**SECTION 96(2) MODIFICATION APPLICATION
ASSESSMENT REPORT
Commercial Development
4 Murray Rose Avenue, Sydney Olympic Park
(SSD 6076 MOD 1)**

Secretary's
Environmental Assessment Report
Modification of consent under section 96(2) of the
Environmental Planning and Assessment Act, 1979

July 2015

Figure 4: Proposed ground floor plan of commercial building

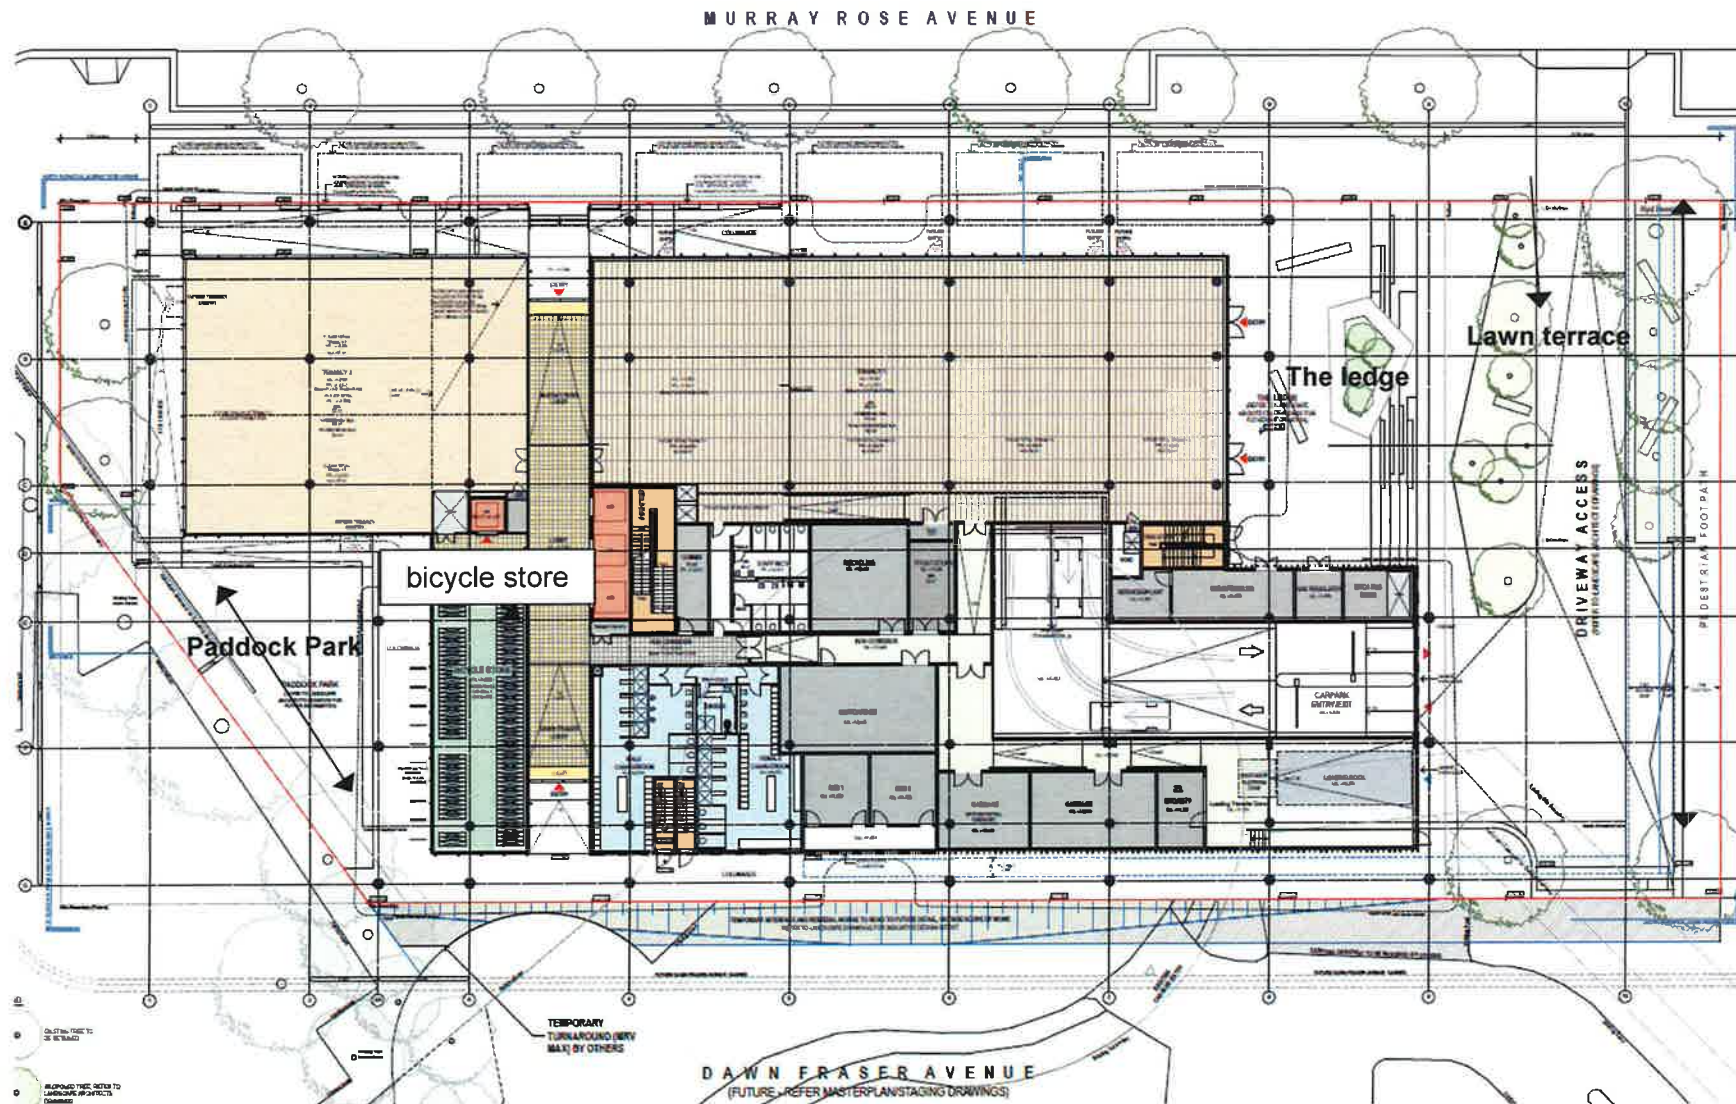
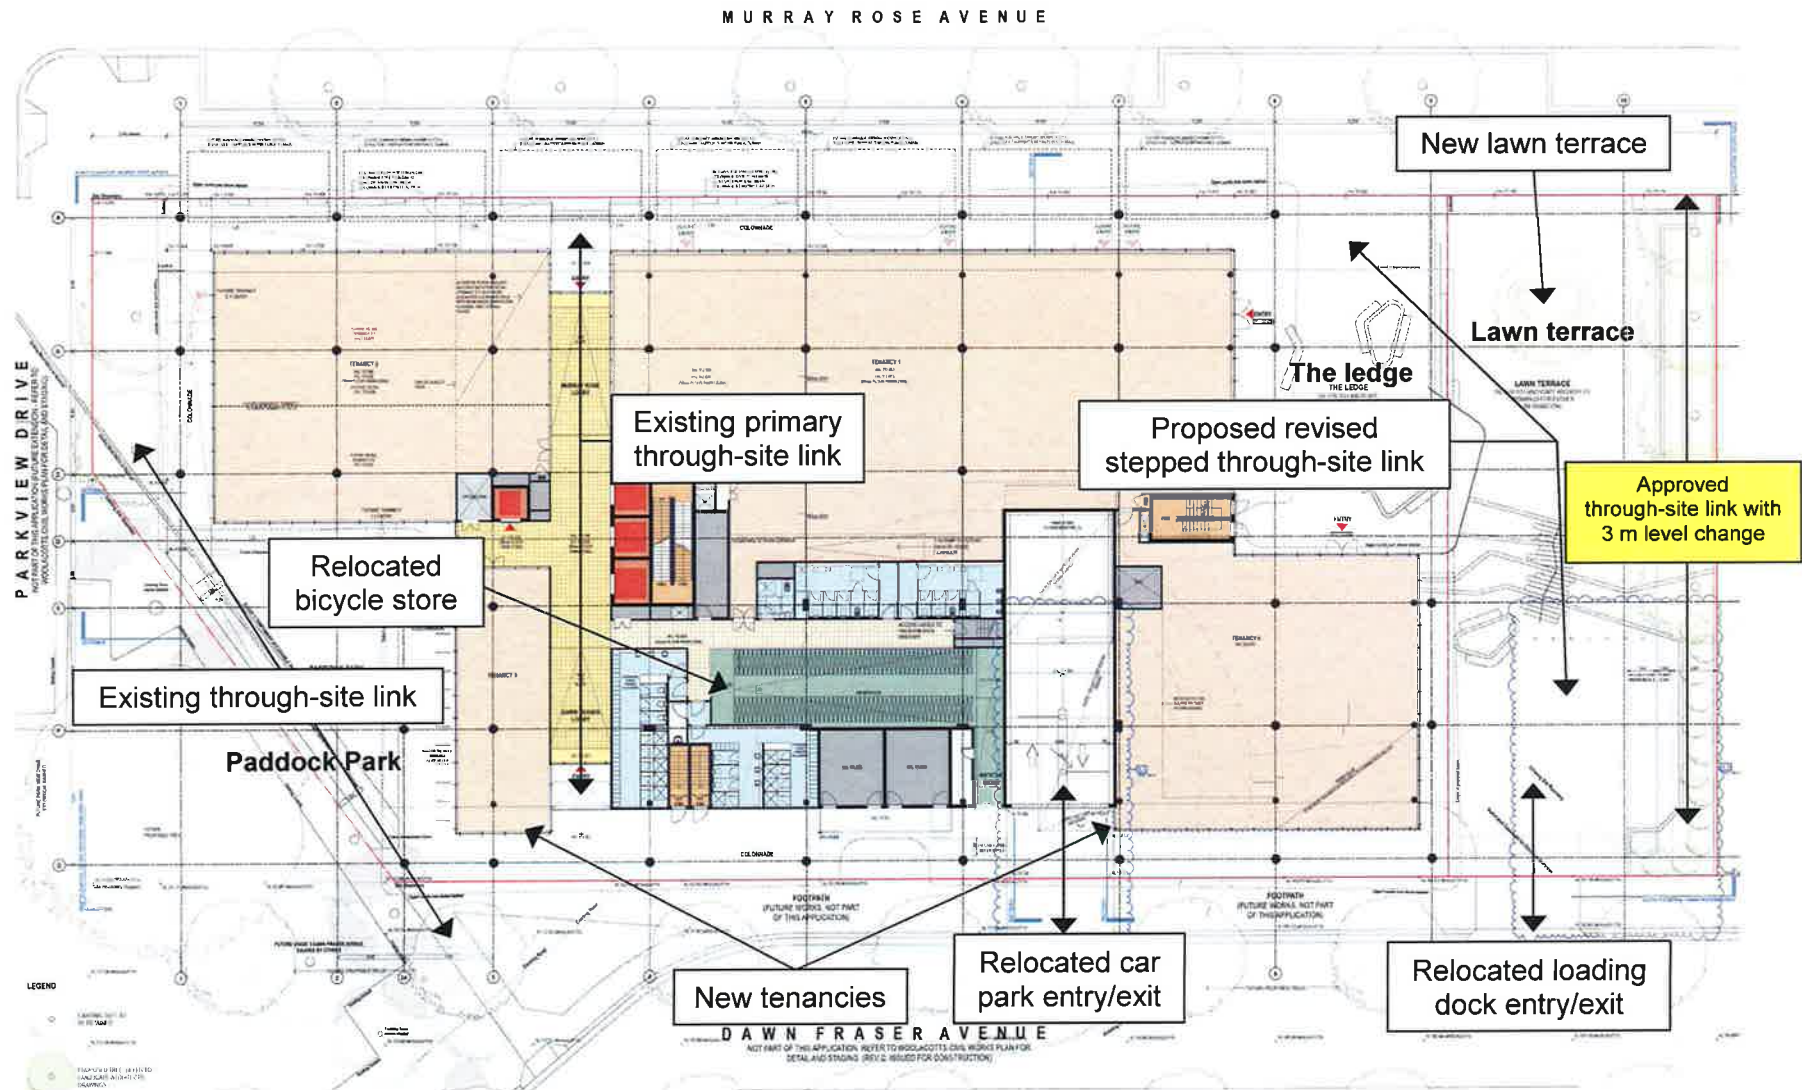
The application seeks approval for internal and external changes to the approved commercial building including additional retail/commercial floor space on the ground floor and relocation of the basement car park entry and loading dock from Murray Rose Avenue to the future Dawn Fraser Avenue.

- relocation of the car park entry/exit from Murray Rose Avenue to Dawn Fraser Avenue;
- relocation (and reconfiguration) of the loading dock, garbage facilities, switch room, back-of-house corridor, staff amenities and fire services from Ground Level to Basement Level 1;

- provision of two additional tenancies at Ground Level;
- provision of 523m² of additional gross floor area (GFA) at Ground Level for commercial use to accommodate office and retail premises;

- relocation of the bicycle store at Ground Level from the south-western corner of the building to be centrally located adjacent to the change room facilities that allows for direct bicycle access off Dawn Fraser Avenue;

The proposed modification seeks approval for internal changes which primarily relate to the relocation and reconfiguration of the loading dock, garbage facilities, switch room, back of house corridor, staff amenities and fire services from the Ground Level to Basement Level 1. This would facilitate the provision of the additional commercial and retail tenancies on the ground floor.

- the proposal complies with the maximum FSR of 2.5:1 for the site;
- the addition of the two retail/commercial tenancies on the Ground Floor would improve the street activation along Dawn Fraser Avenue;
- the proposed changes do not result in changes to the overall height, bulk, scale or external appearance of the approved development; and
- no additional amenity impacts on neighbouring properties would occur.
